H. B. ROBINSON STEAM ELECTRIC PLANT UNIT NO. 2

AMENDMENT TO FACILITY OPERATING LICENSE

Amendment No. 26
License No. DPR-23

SAFETY EVALUATION BY THE OFFICE OF NUCLEAR REACTOR REGULATION

Figure 3.1-1

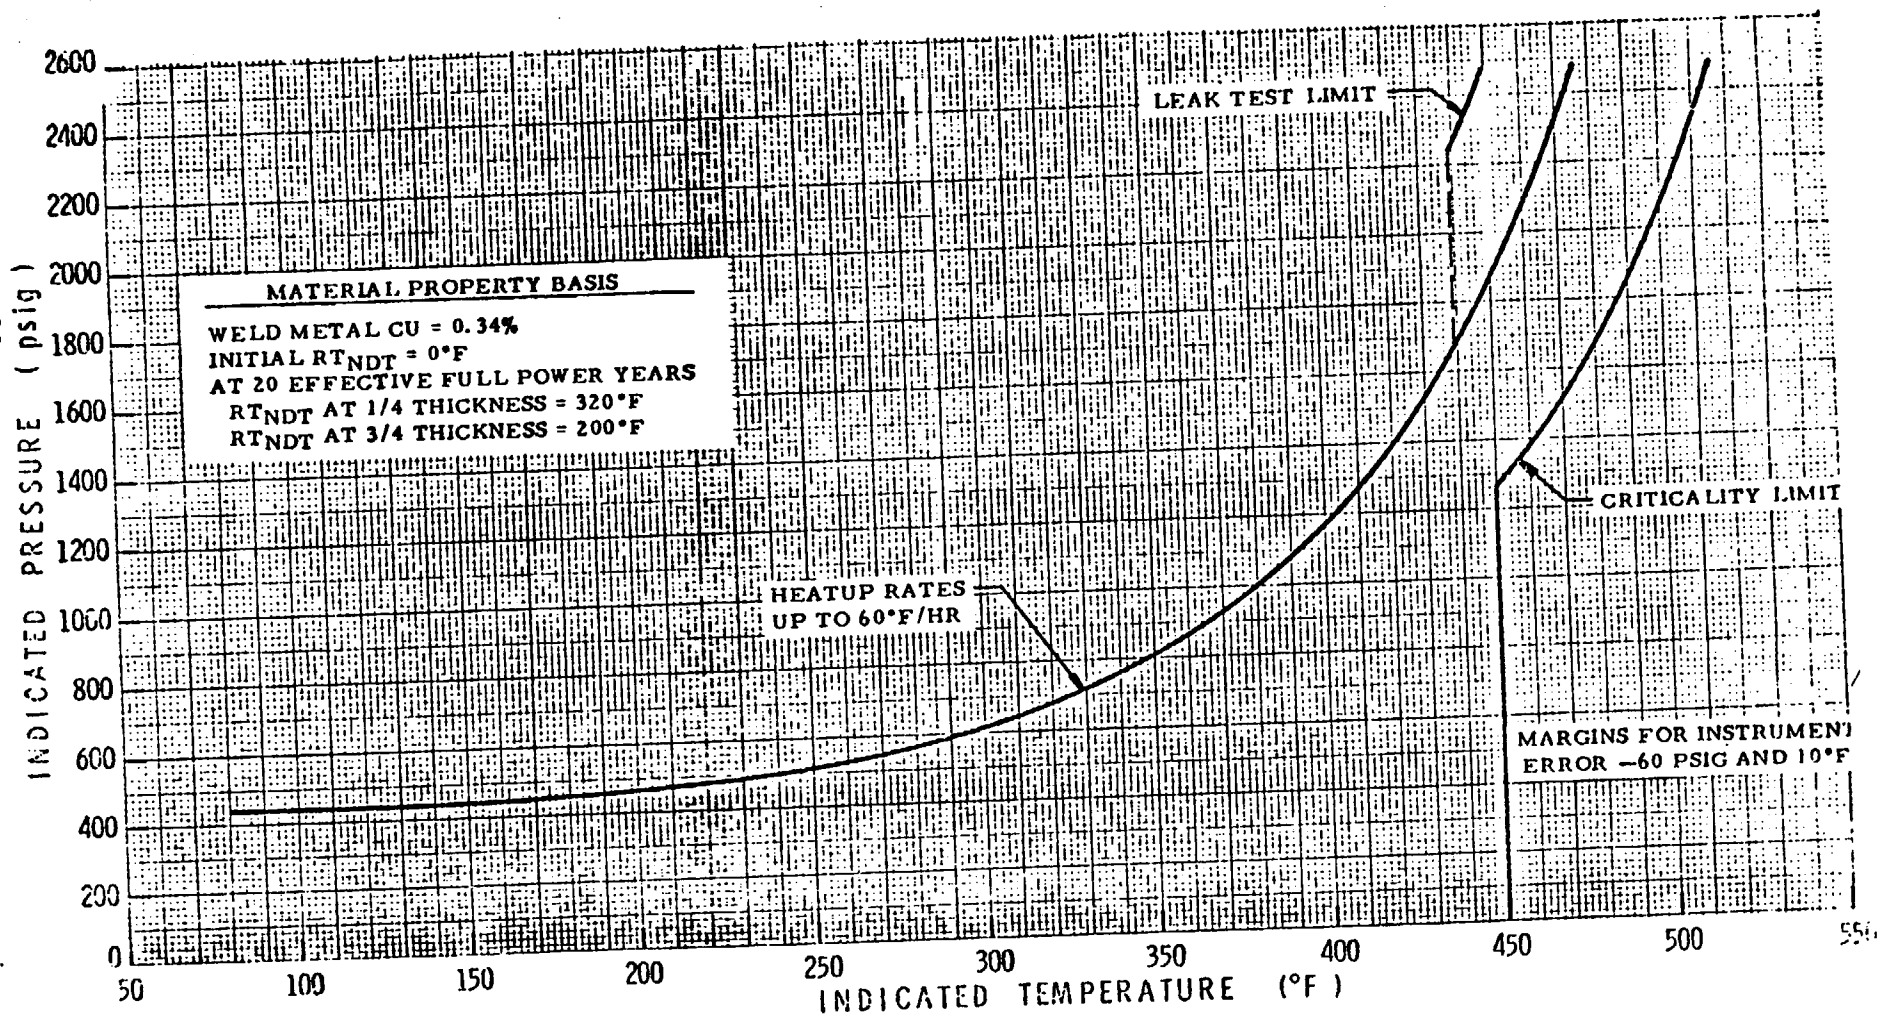
This amendment specifies more restrictive limits on the reactor coolant system pressure and temperature during system heatup and cooldown and when the reactor is critical.

Item 1 of the licensee's request was made in conformance with the provisions of Appendix A Technical Specification 3.1.2.4 which requires that Figures 3.1-1 and 3.1-2 (which define the pressure-temperature limits for heatup, cooldown, and criticality) be updated before the calculated fast neutron exposure of the reactor vessel exceeds the exposure for which the figures apply.

REACTOR COOLANT SYSTEM HEATUP LIMITATIONS - APPLICABLE FOR
PERIODS UP TO 20 EFFECTIVE FULL POWER YEARS

The proposed pressure-temperature operating limits for Robinson-2 have been calculated for operation through 20 EFPY. Based on information submitted by the licensee, the limiting material with respect to RT_{NDT} shift is weld material in the reactor vessel beltline having 0.34% copper. Its initial RT_{NDT} shift due to irradiation at 20 EFPY (fluence of 1.9×10^{19} n/cm²) is 3200F at 1/4T location. This shift in RT_{NDT} was obtained by extrapolating the data on weld material in capsule V that was subjected to a fluence of 4.51×10^{18} n/cm². The extrapolation followed the upper limit curve in Regulatory Guide 1.99, Revision 1 (in publication).

We have reviewed the pressure-temperature operating limits proposed for H. B. Robinson, Unit No. 2 and conclude that they conform to Appendix G, 10 CFR Part 50 and that they are acceptable for operation through 20 EFPY. The use of Appendix G in establishing safe operating limitations will ensure adequate safety margins during operation, testing, maintenance and postulated accident conditions and constitute an acceptable basis for satisfying the requirements of NRC General Design Criterion 31, Appendix A, 10 CFR Part 50.
